ADDENDUM NO. 3

Reference: **New Canada Road (PIN 107036.00)**
City of Lakeland
Shelby County, TN

The following additions, deletions, and/or revisions shall be made part of the Plans dated **August 30, 2024**, for the referenced project. This addendum shall have precedence over the plans and specifications on all items listed and described herein; however, it shall not change the intent and requirement of the plans and specifications for any item not specifically mentioned.

6/20/2025 11:40:51 AM
W:\7008\Transportation_Split\7008 XS_SouthConnectorCanadaRoad.sht

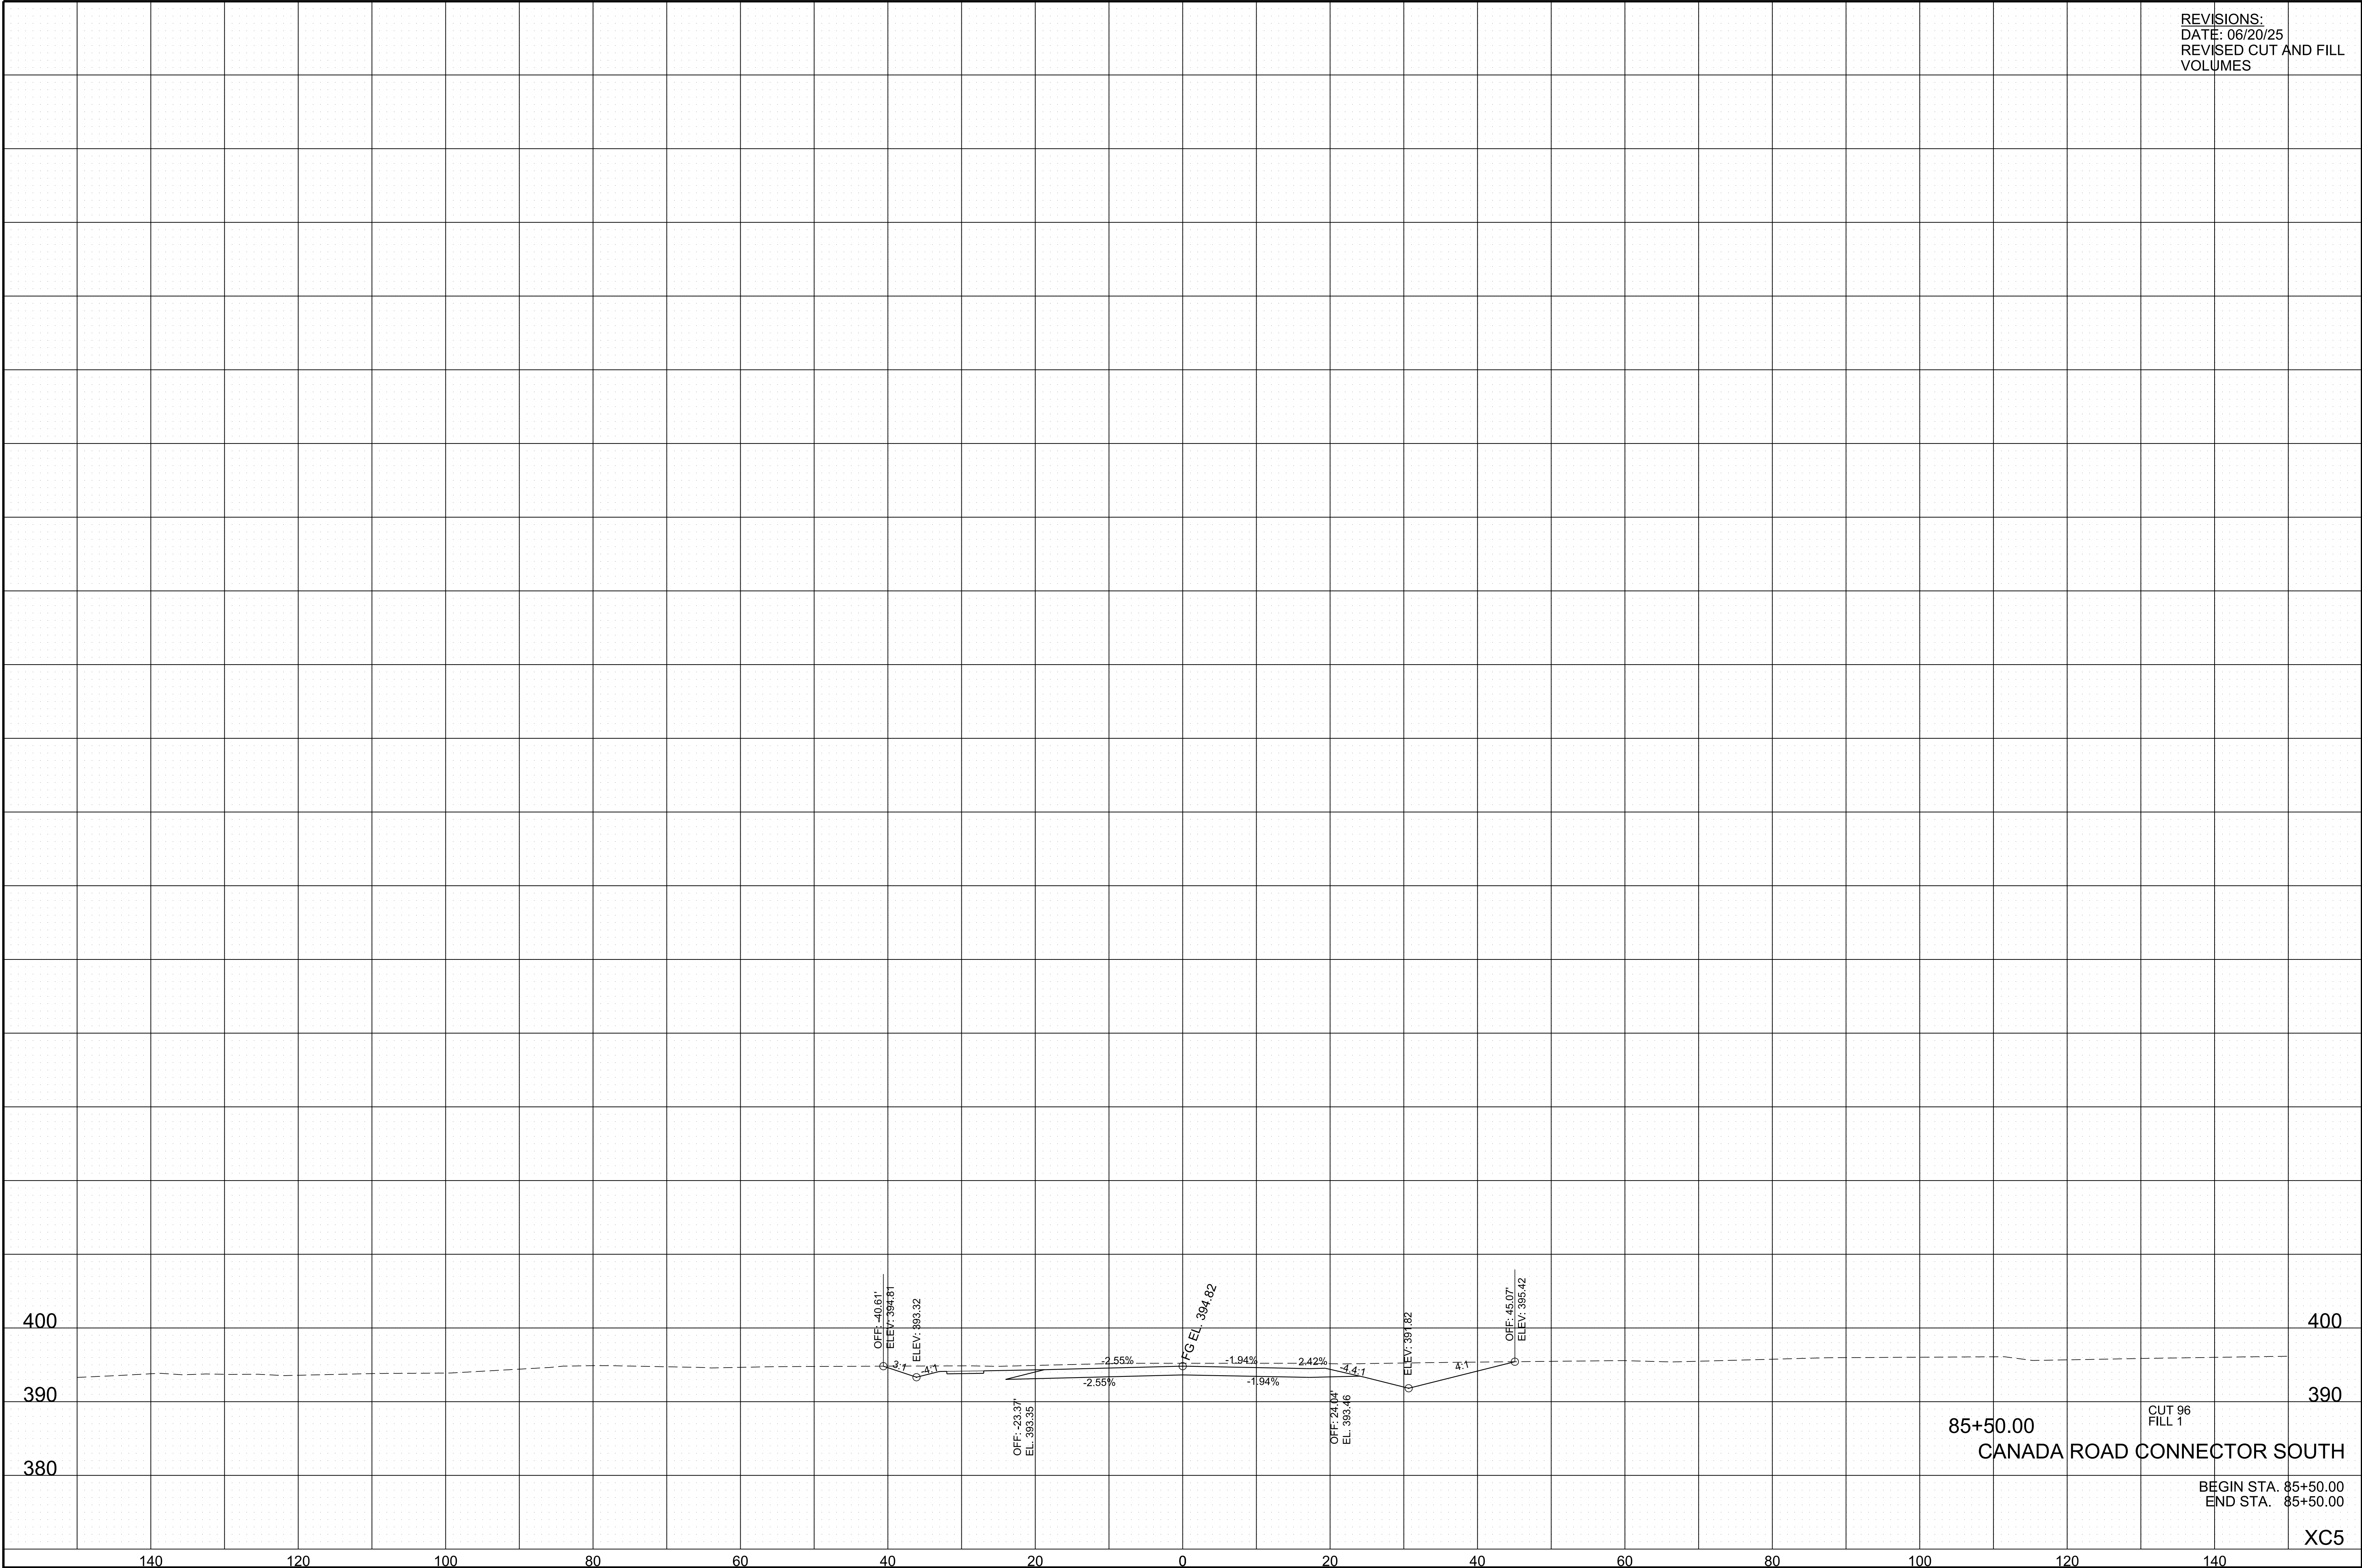
The following plan sheets have been revised and are included with this addendum: 2, 2-1, 2F7 and XC1 – XC5 (Canada Rd. Connector South cross sections).

REVISIONS:	
DATE: 06/20/25	
REVISED CUT AND FILL VOLUMES

REVISIONS:	
DATE: 06/20/25	
REVISED CUT AND FILL VOLUMES

REVISIONS:
DATE: 06/20/25
REVISED CUT AND FILL
VOLUMES
